METROPOLITAN GOVERNMENT OF NASHVILLE AND DAVIDSON COUNTY

STAFF RECOMMENDATION
2401 Fairfax Avenue
August 21, 2013

Application: New construction - infill
District: Hillsboro-West End Neighborhood Conservation Zoning Overlay
Council District: 18
Map and Parcel Number: 10411017100
Applicant: Michael Ward, Allard Ward Architects, LLC
Project Lead: Melissa Baldock, melissa.baldock@nashville.gov

① Site Plan
Scale: 1" = 20'-0"

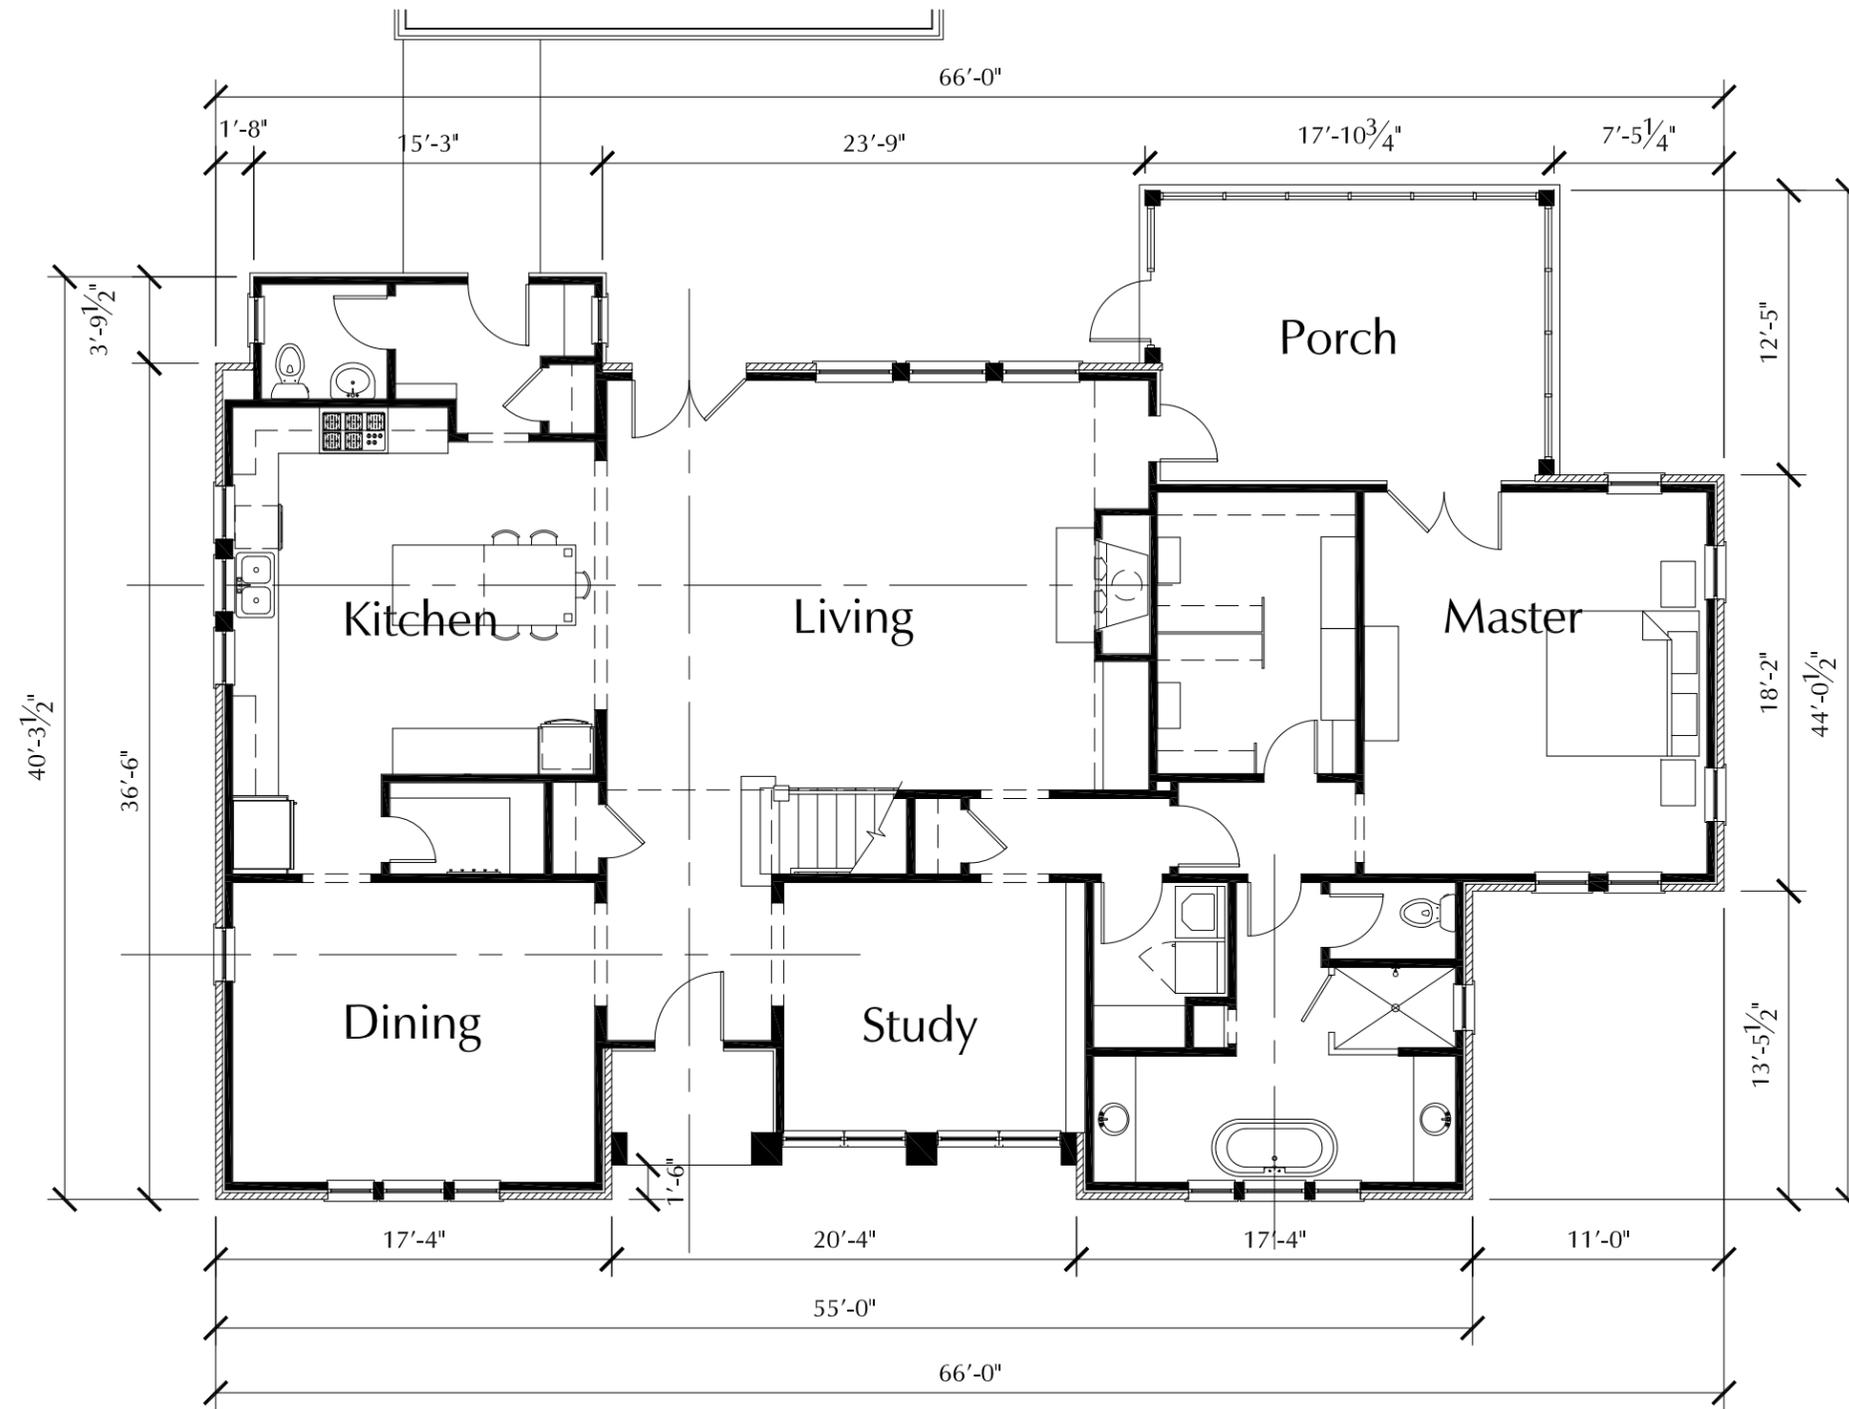
Setback and Rhythm of Spacing: The front setback will match the setback of the new infill approved for 2403 Fairfax Avenue, which in turns matches the setback of the existing historic dwelling at 2405 Fairfax Avenue. The structure will be five feet (5') from the right side property line, and twelve feet (12') from the 24th Avenue South side property line. The project meets the base zoning setback requirements, and staff finds that the project meets section II.B.c of *Hillsboro-West End Neighborhood Conservation Zoning Overlay: Handbook and Design Guidelines*.

Outbuilding: An accessory structure is planned and shown on the site plan, but elevations were not submitted as a part of the project.

MHZC Note:
Garage not part of
this application.
